Addendum No. 8

Reference: Beverley Taylor Sorenson Center for the Arts
Southern Utah University – Cedar City, Utah
DFCM Project No. 12218730

Subject: **Addendum No. 8**

| project | Southern Utah University Beverley Taylor Sorenson Center for the Arts Utah Shakespeare Festival Facility |

Add Alternate #4 Site Plan A6
1" = 30'-0"

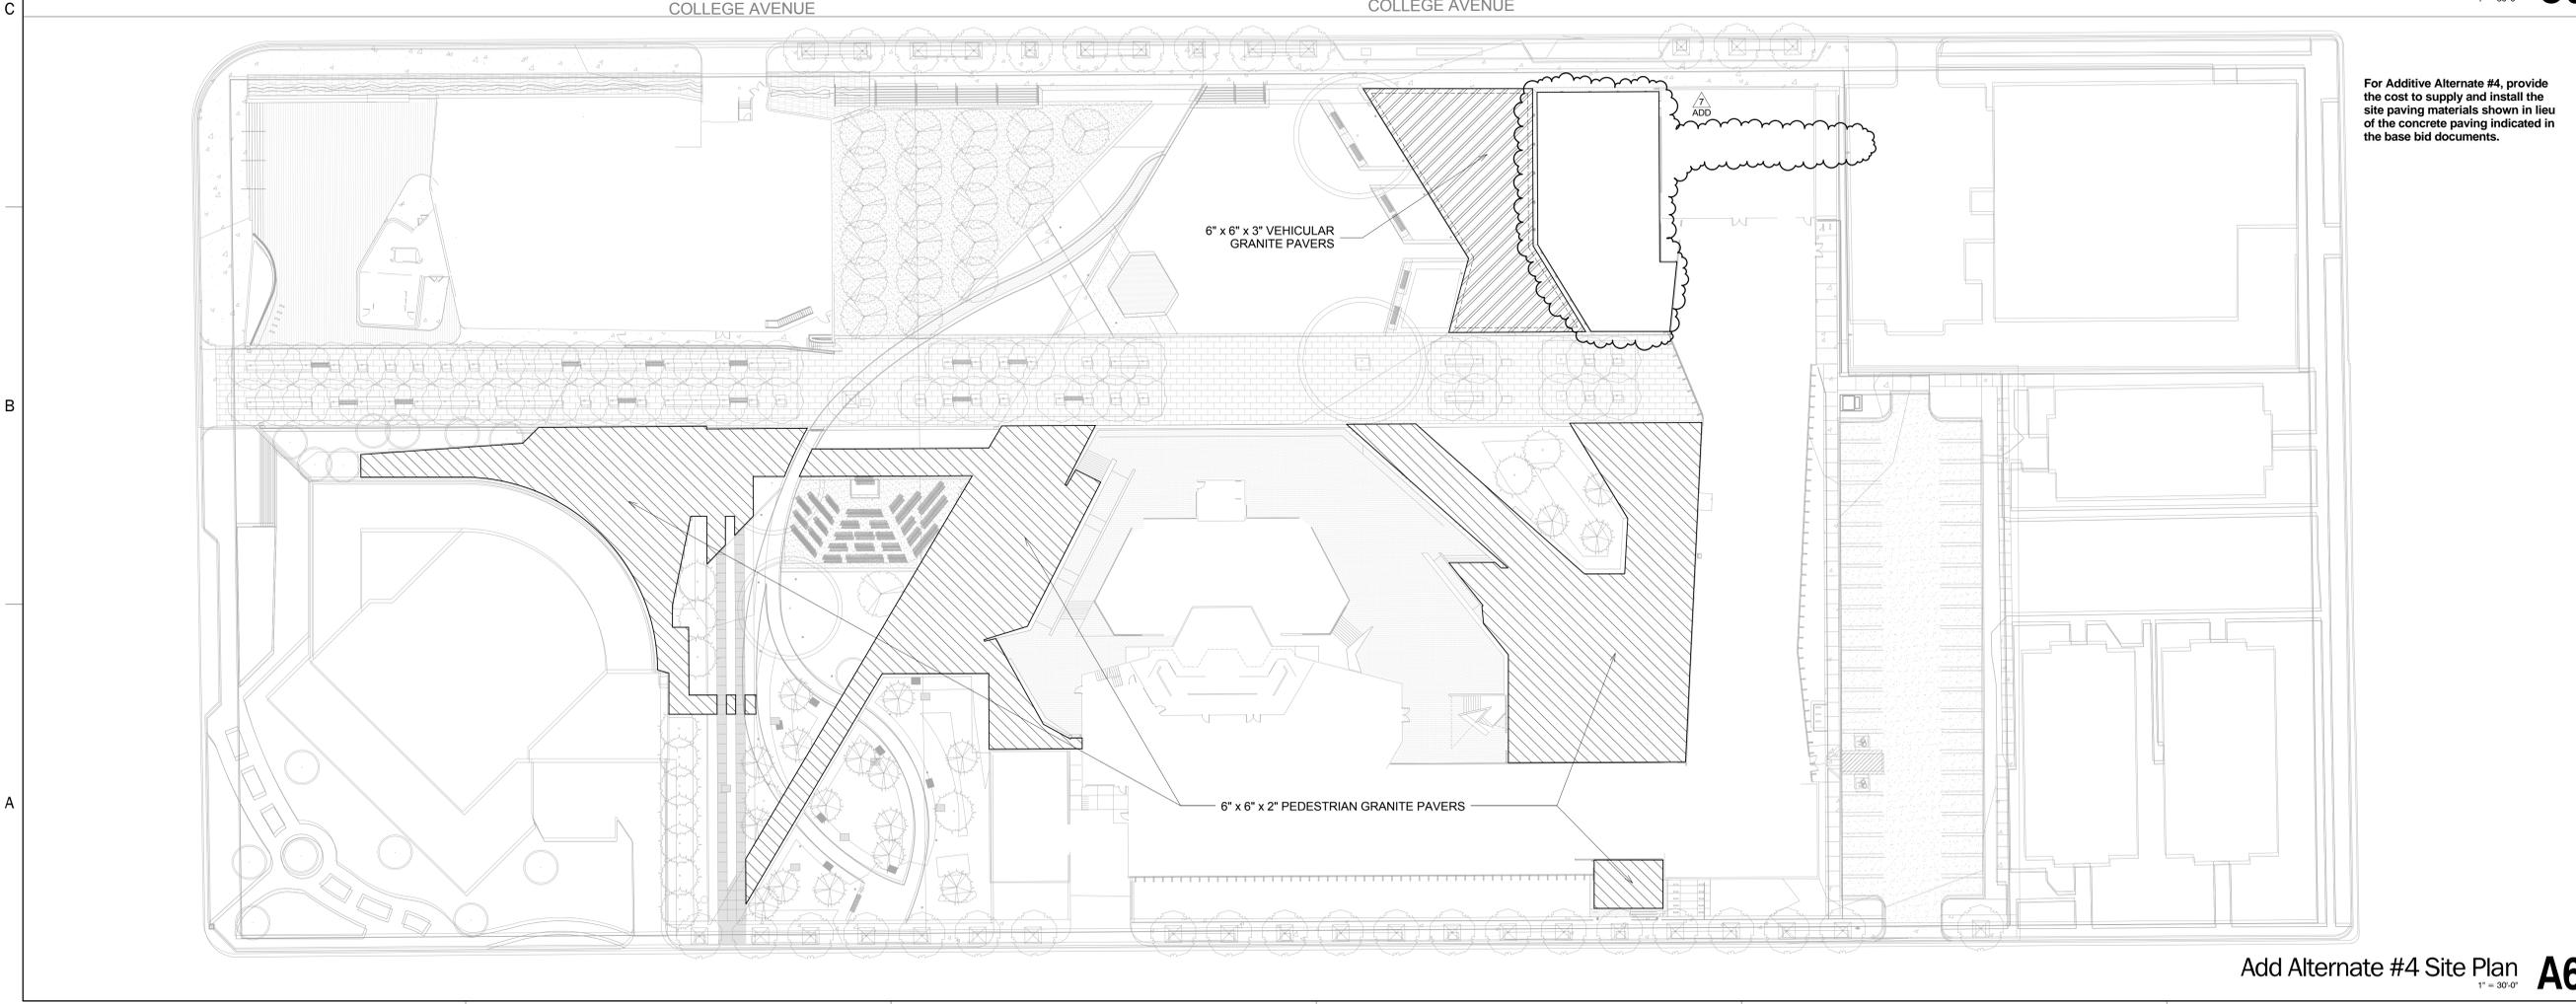
| item # | revision or clarification | sheet/drawing | description |
|-----------------------|---------------------------|---------------|--|
| | clarification | U-GI104/A6 | The area previously indicated by the note: "6" x 36" NARROW MODULAR PRECAST CONC. PAVERS" has been removed from this drawing. The precast pavers to the west of the studio theater should be part of Alternate #1, as indicated on U-AS101B. They are not part of Alternate #4. |

For Additive Alternate #4, provide the cost to supply and install the site paving materials shown in lieu of the concrete paving indicated in the base bid documents.

Tower Stair Section **A3**
1/2" = 1'-0"

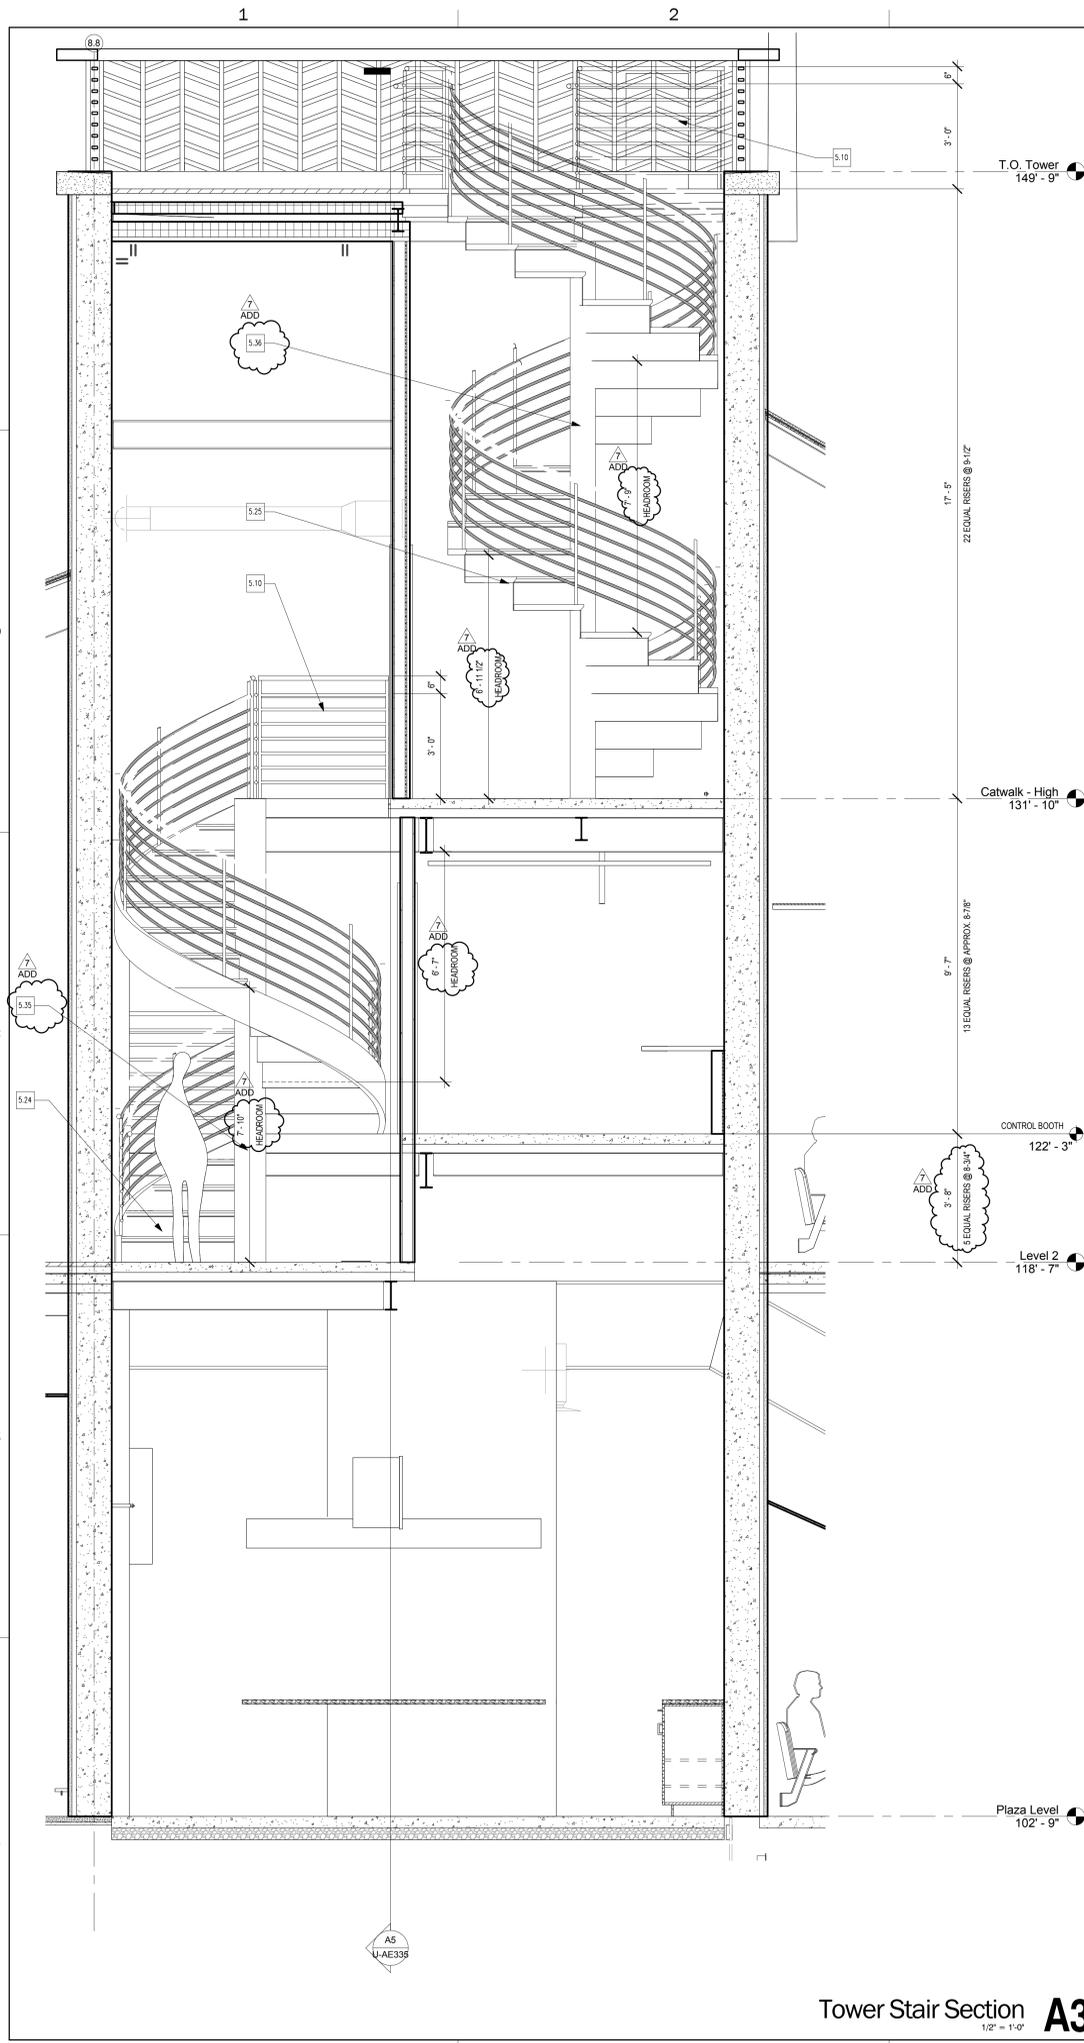
| item # | revision or clarification | sheet/drawing | description |
|-----------------------|---------------------------|---------------|--|
| | clarification | U-AE335/A3 | <ul style="list-style-type: none"> Clarified center post size as 10" steel pipe (10-5/8" outer diameter) for plaza level to control booth and control booth to catwalk access spiral stair runs; 8" steel pipe (8-5/8" outer diameter) for catwalk access to tower roof spiral stair run. Added dimensional clarification for plaza level to control booth spiral run Added headroom dimensions for clarification |

Tower Stair and Elevator Section **A5**
1/2" = 1'-0"

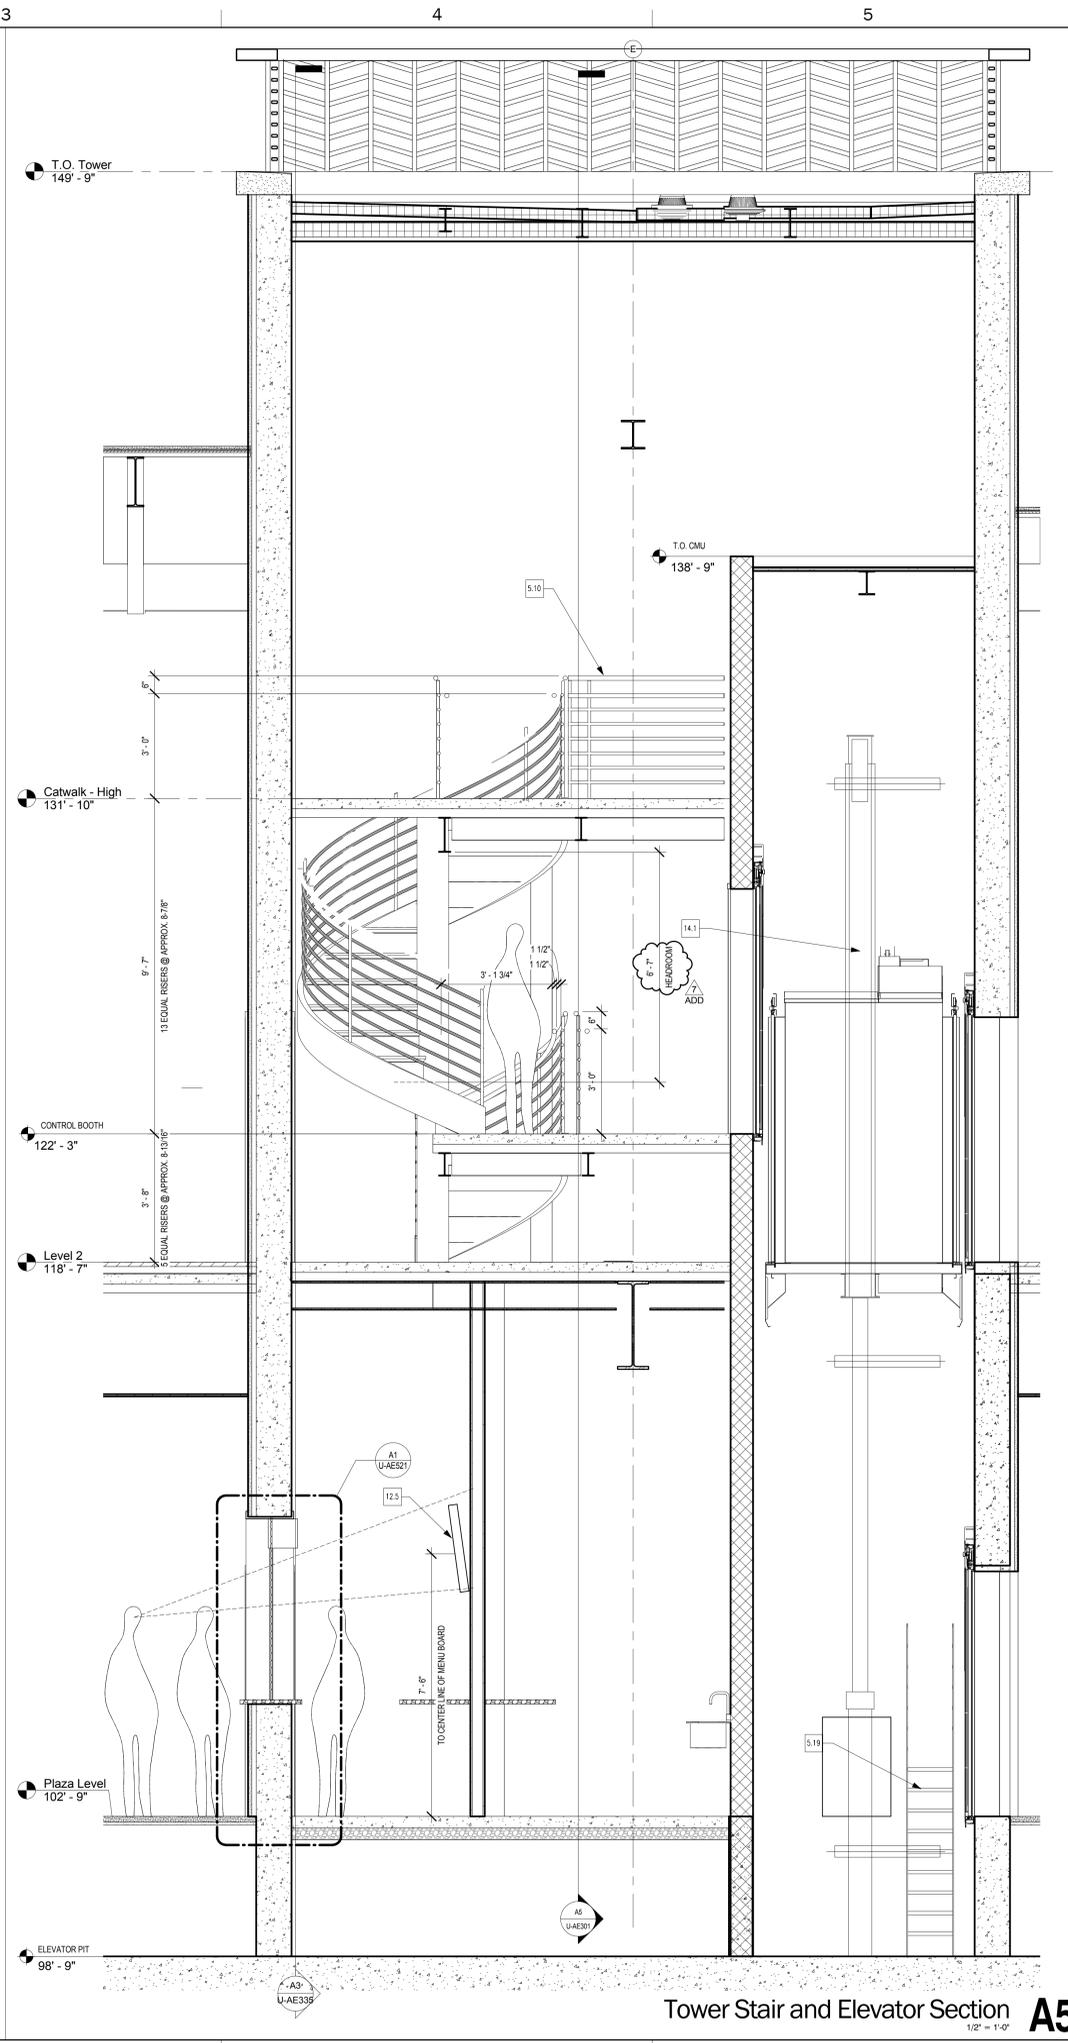
| item # | revision or clarification | sheet/drawing | description |
|-----------------------|---------------------------|---------------|--|
| | clarification | U-AE335/A5 | Added headroom dimensions for clarification |

Enlarged Plans & Elevations
U-AE404

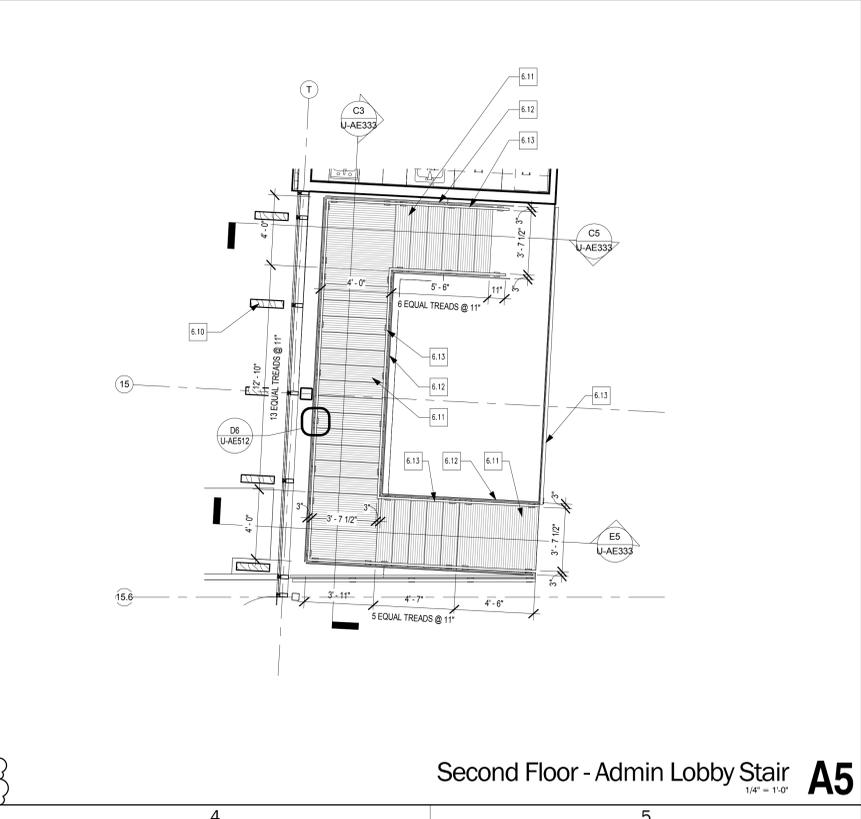
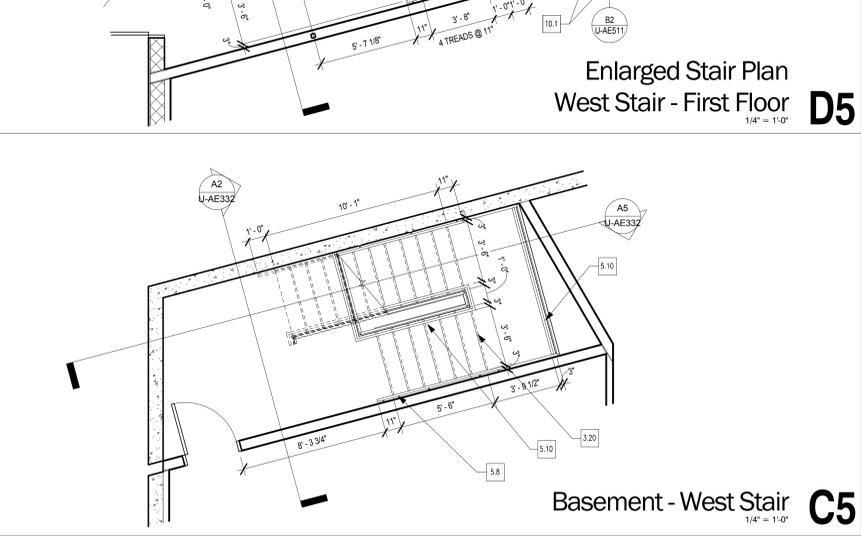
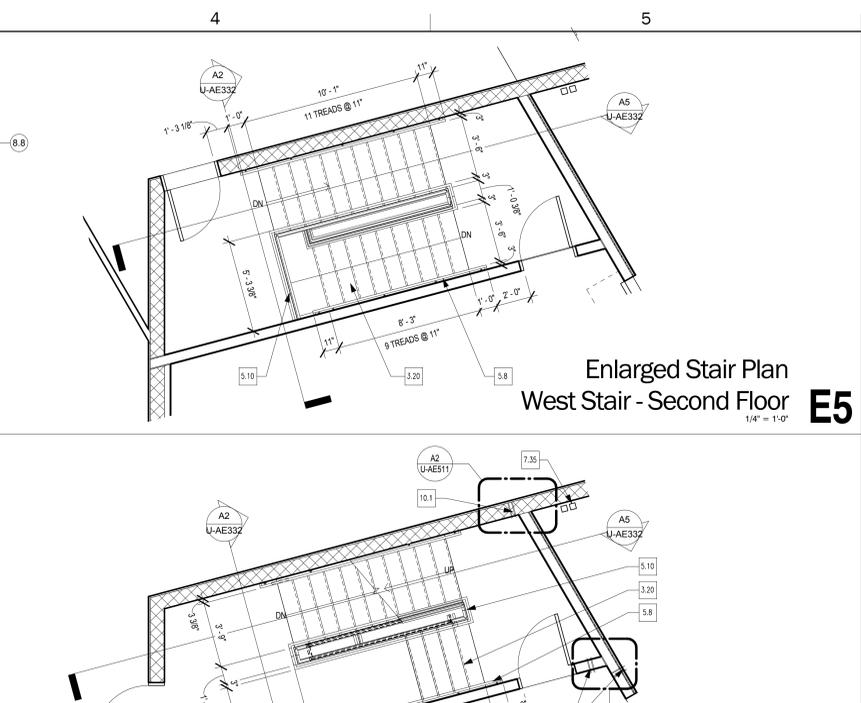
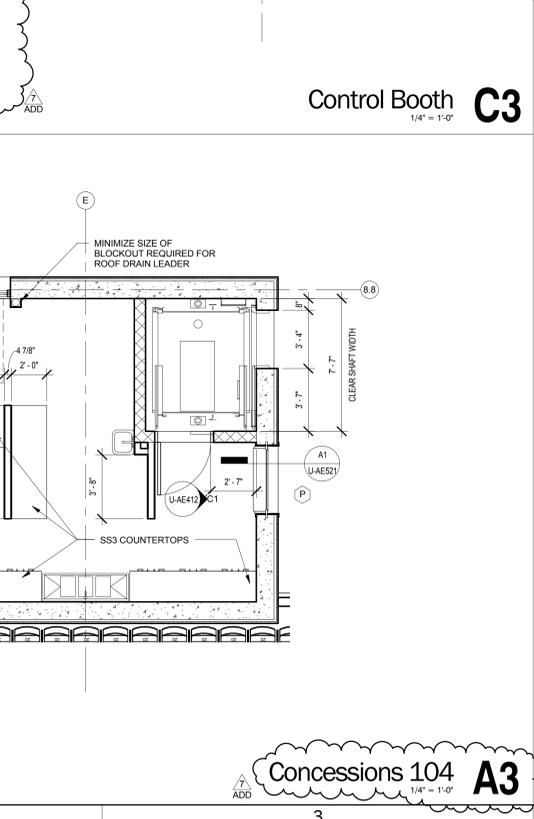
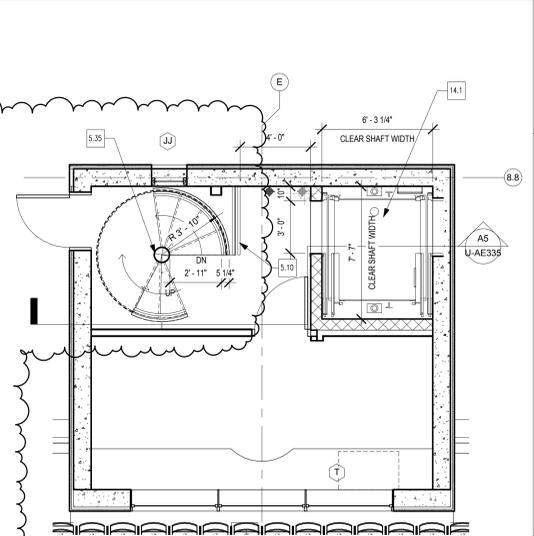
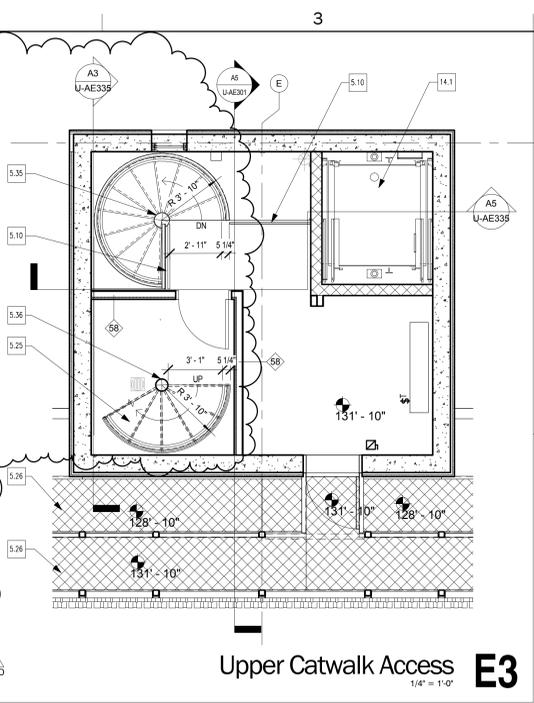
| | Clarification | U-AE404/D4 | Interior elevation has been added |
| | Clarification | U-AE404/D5 | Dimensions and interior elevations have been added |
| | Clarification | U-AE404/E4 | Interior elevation has been added |
| | Clarification | U-AE404/E5 | Interior elevation has been added |

Decorative Gravel Box Detail C4
1" = 1'-0"

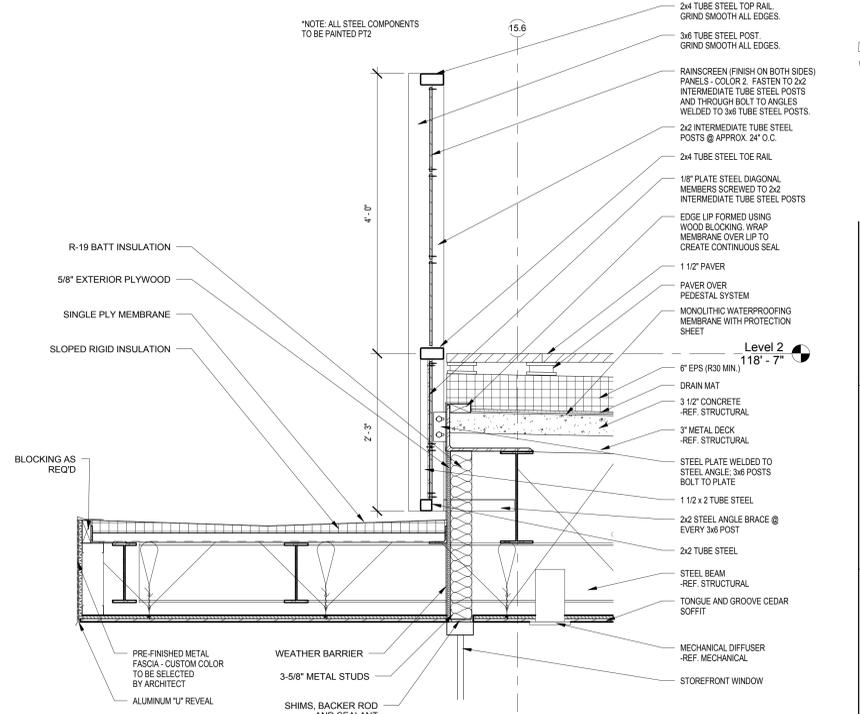
| | clarification | U-AE525/C4 | Added section detail to clarify finishes of the decorative gravel boxes |

A1 FOOTING & FOUNDATION PLAN - AREA A
U-SB101A SCALE: 1/8" = 1'-0"

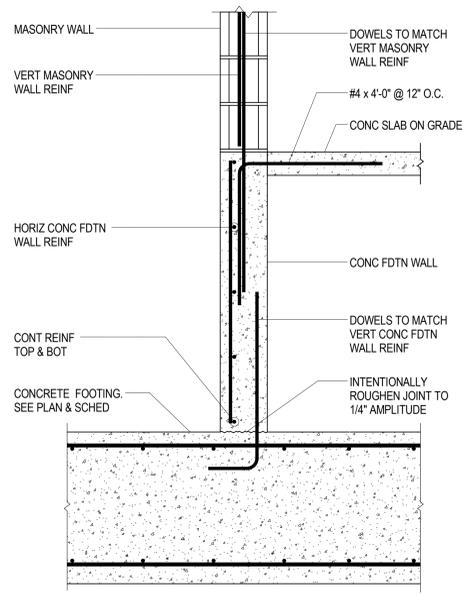
| STRUCTURAL | | | |
|-------------------------|---------------|----------|---|
| | Clarification | U-SB101A | Added detail references. |
